TOWN OF SEABROOK, NEW HAMPSHIRE

WWTF UPGRADES (SEABROOK BID NO. B2024-SWR-14; CWSRF NO. CS-334178-04)

ADDENDUM NO. 1

To be considered as part of the contract drawings and specifications for the WWTF Upgrades (Seabrook Bid no. B2024-SWR-14; CWSRF no. CS-334178-04), dated 01/04/2024:

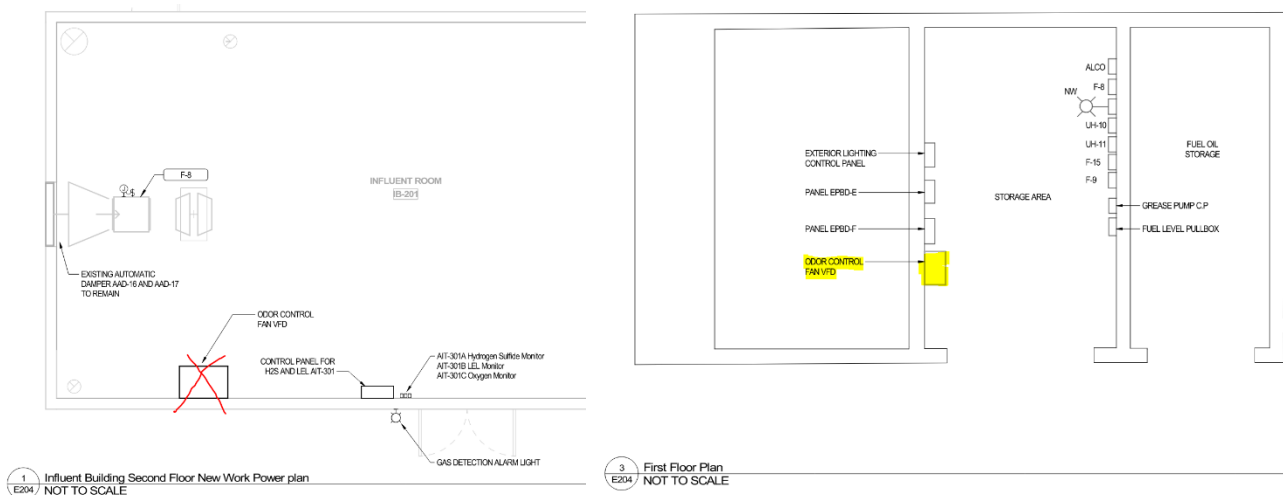
1. Table of Contents
 - a. Remove section 40 92 49.13 from the Table of Contents as VFDs are covered in Section 26 29 23.
2. Section 01 22 00 Measurement and Payment – Attachment 1
 - a. Add the attached approved quote from Wilson Controls regarding the scope of work covered in the allowance described in Bid Item no. 2 (\$85,000). This quote shall be added to the end of Section 01 22 00 for reference.
3. Section 40 91 00 Instrument List
 - a. Add the following rows to the Field Instrument schedule:

PS-302	Pressure Switch	Centrifuge Feed Pump no. 1	0 to 100 psi	NEMA 4X NEMA 4X	120 VAC
PS-304	Pressure Switch	Centrifuge Feed Pump no. 2	0 to 100 psi	NEMA 4X NEMA 4X	120 VAC

BID ALTERNATE NOTE:

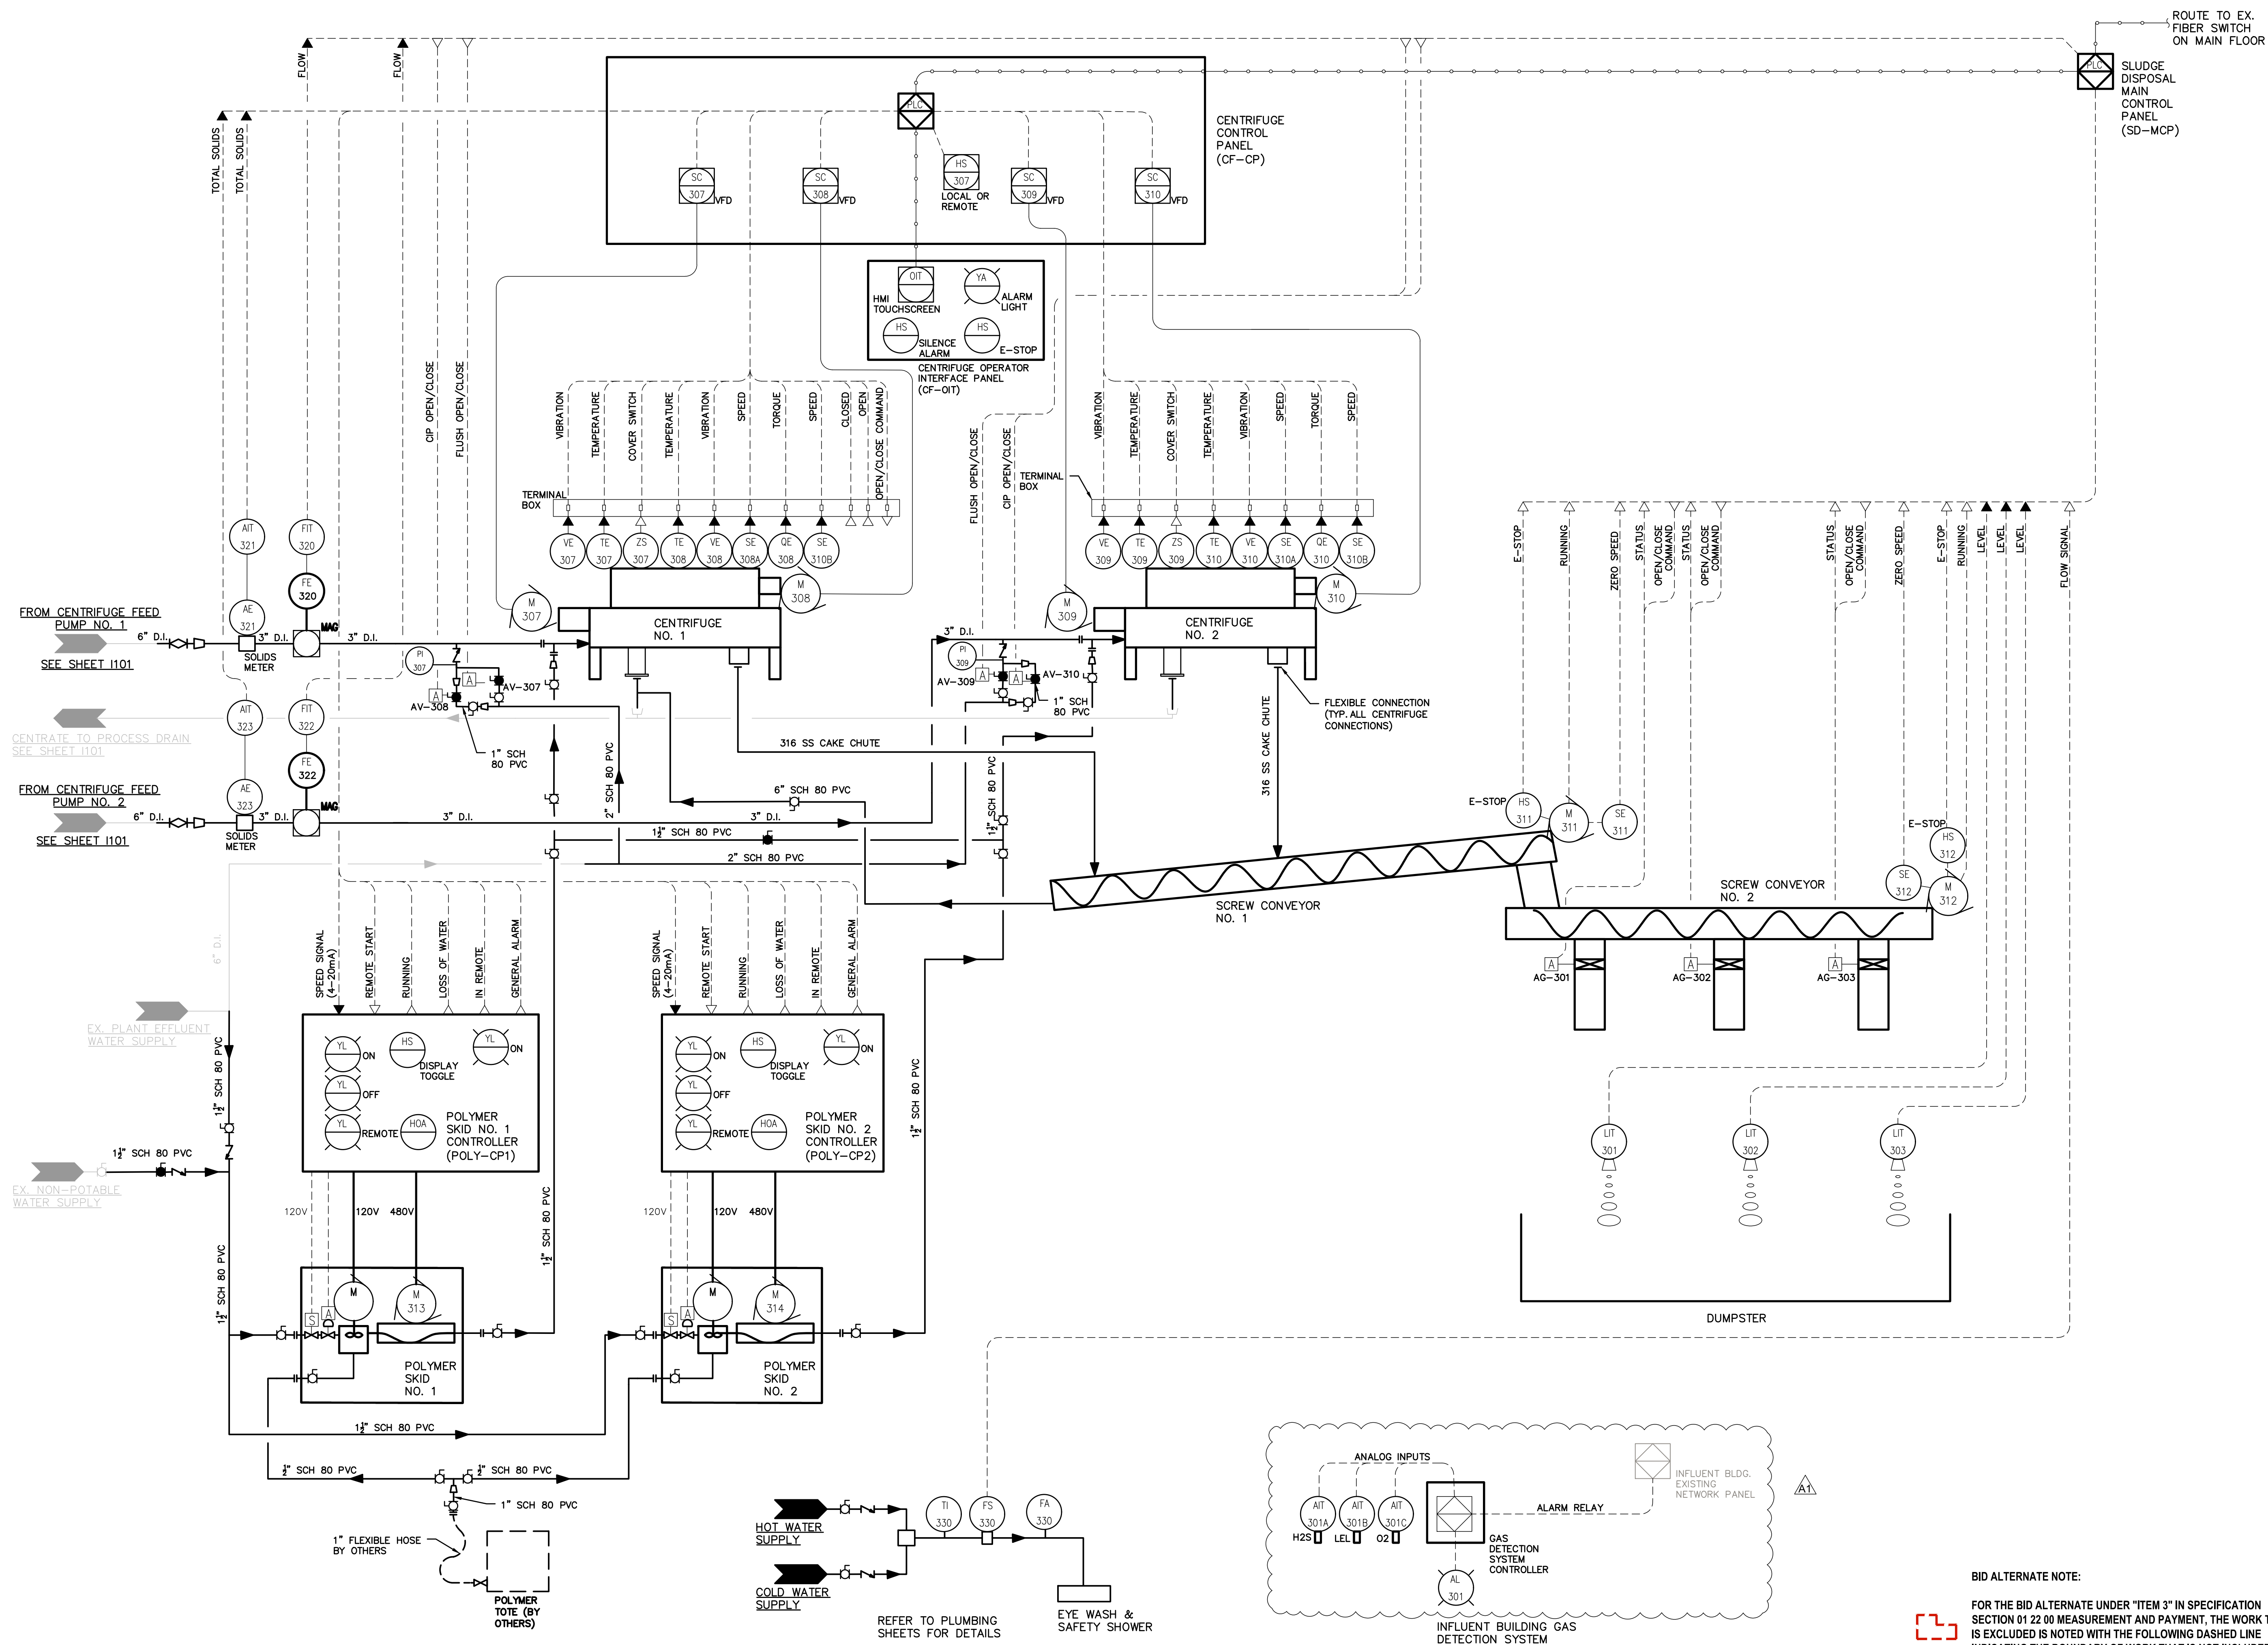
FOR THE BID ALTERNATE UNDER "ITEM 3" IN SPECIFICATION SECTION 01 22 00 MEASUREMENT AND PAYMENT, THE WORK THAT IS EXCLUDED IS NOTED WITH THE FOLLOWING DASHED LINE INDICATING THE BOUNDARY OF WORK THAT IS NOT INCLUDED FOR BID ALTERNATE "ITEM 3". ALL ASSOCIATED ELECTRICAL, STRUCTURAL, AND/OR ARCHITECTURAL MODIFICATIONS SHALL BE EXCLUDED IN THIS BID ALTERNATE AS WELL.
